# **Juneau Access Improvements Project Draft Supplemental Environmental Impact Statement**

## **2014 Update to Appendix P Anadromous and Resident Fish Streams Technical Report**

## **ERRATA SHEET**

Figure 1. Streams in the Project Area

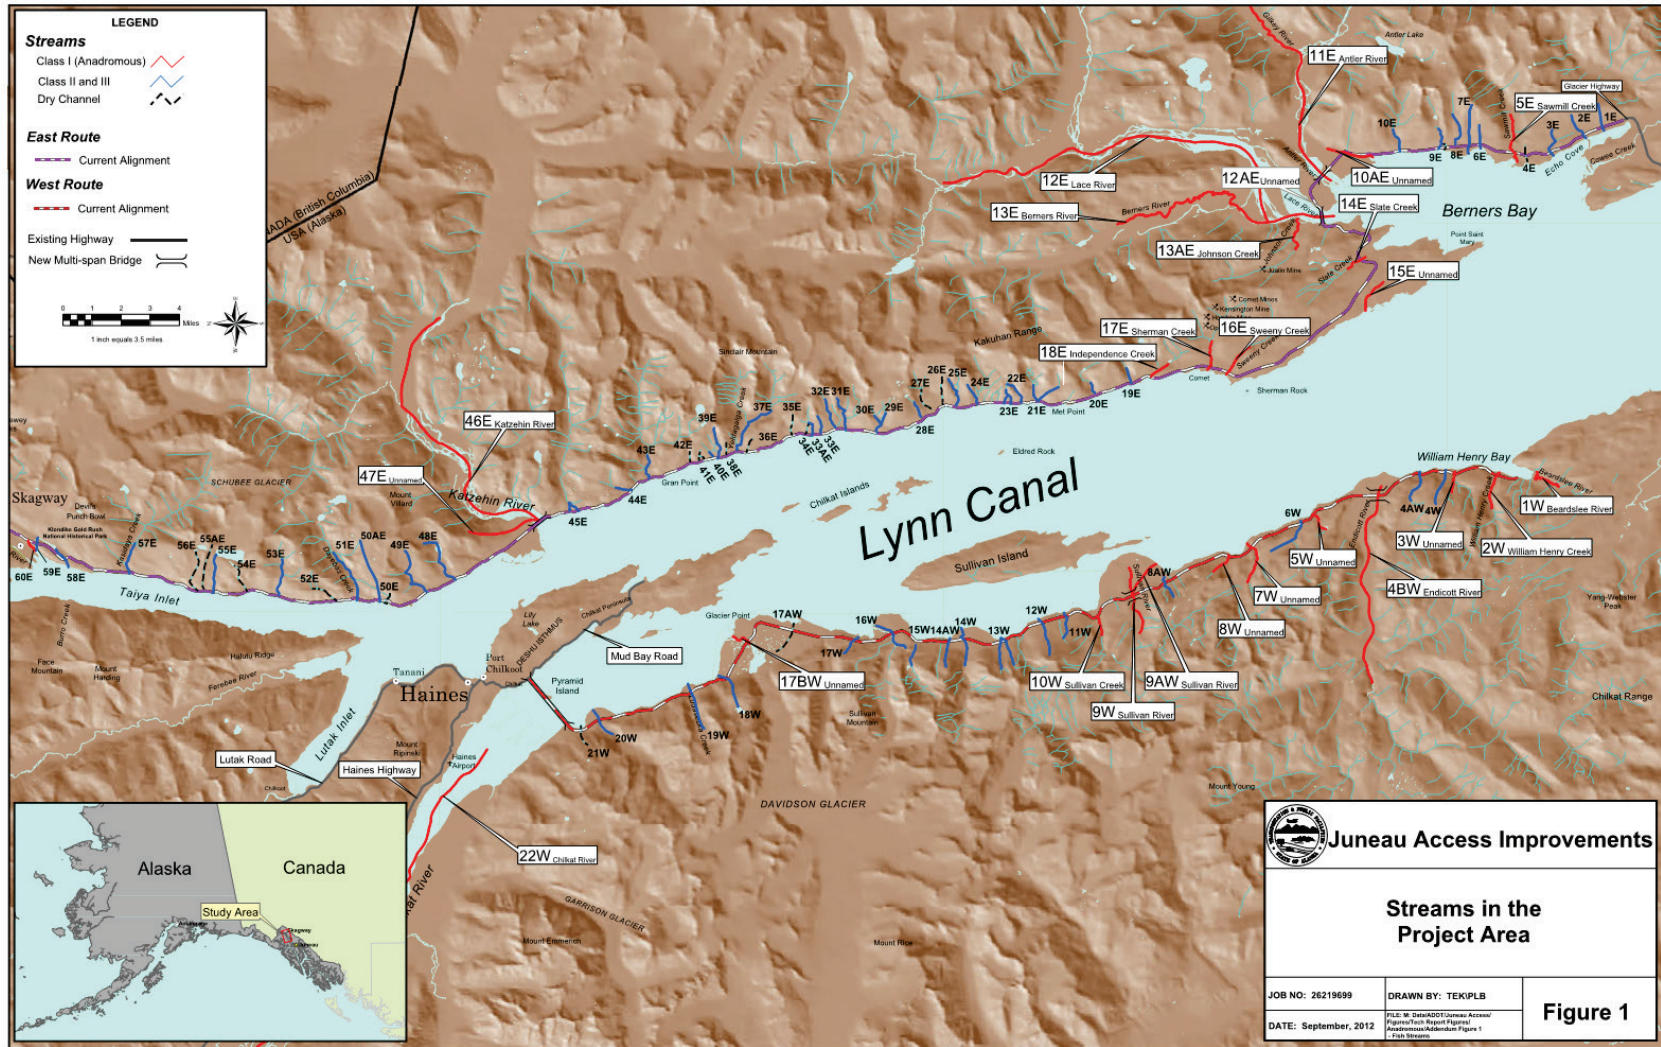
9. Page 4-7, Table 4-2, West Lynn Canal Stream Crossings by Structure. Correction to 1st column, 4th row: “4W, 4AW, 14W, 15W, 19W (Ludaseska Creek).”
10. Figure 3-1, Sturgill’s creek (59E) added as a Class II stream on revised Figure 1.

11. Figure 3-1, Pullen (60E) creek and Unnamed 12AE added as a Class I anadromous streams on revised Figure 1.
12. Figure 3-1, Title correction has been made in revised Figure 1 as “Streams in the Project Area.”

13. Figure 3-1, Stream 51E: The name of Stream 51E has been corrected in revised Figure 1 to “Dayebas Creek.”
14. Figure 3-1, Stream 6E: Stream 6E is correctly depicted as a Class IIA stream and not as a dry channel, as was the case in the October 2004 Figure 3-1.

15. Figure 3-1, Stream 7E: Stream 7E is correctly depicted as being south of its location on the October 2004 Figure 3-1, as was originally depicted on the 1997 DEIS figure.

16. Figure 3-1, Stream 8E: In the October 2004 Figure 3-1, stream 8E appeared to be an outlet of Stream 9E. In the revised Figure 1, stream 8E has been correctly identified as located south of stream 9E at the location labeled stream 7E in the October 2004 Figure 3-1. Stream 8E is also a dry channel with no stream number as corrected on the revised Figure 1.

17. Figure 3-1, Stream 9E: The configuration of stream 9E has been revised. In the October 2004 Figure 3-1, stream 9E appeared to have two forked outlets; however, if there are two outlets, one outlet is currently dry. The revised stream configuration, presented in Figure 1, now matches the 1997 DEIS figure.

This section presents Figure 1, “Streams in the Project Area.” The figure is a revised version of Figure 3-1, which was originally provided in the 2004 *Anadromous and Resident Fish Streams Technical Report*. Below are revisions included in Figure 1:

- Sturgill’s creek (59E) added as a Class II stream.
- Pullen (60E) creek and Unnamed 12AE added as a Class I anadromous streams.
- Title correction has been made in revised Figure 1 as “Streams in the Project Area.”

- Stream 51E: The name of Stream 51E has been corrected in revised Figure 1 to “Dayebas Creek.”
- Stream 6E: Stream 6E is correctly depicted as a Class IIA stream and not as a dry channel, as was the case in the October 2004 Figure 3-1.

- Stream 7E: Stream 7E is correctly depicted as being south of its location on the October 2004 Figure 3-1, as was originally depicted on the 1997 DEIS figure.

- Stream 8E: In the October 2004 Figure 3-1, stream 8E appeared to be an outlet of Stream 9E. In the revised Figure 1, stream 8E has been correctly identified as located south of stream 9E. This location was labeled stream 7E in the October 2004 Figure 3-1. Stream 8E is also a dry channel with no stream number as corrected on the revised Figure 1.

- Stream 9E: The configuration of stream 9E has been revised. In the October 2004 Figure 3-1, stream 9E appeared to have two forked outlets; however, if there are two outlets, one is currently dry. The revised stream configuration, presented in Figure 1, now matches the 1997 DEIS figure.
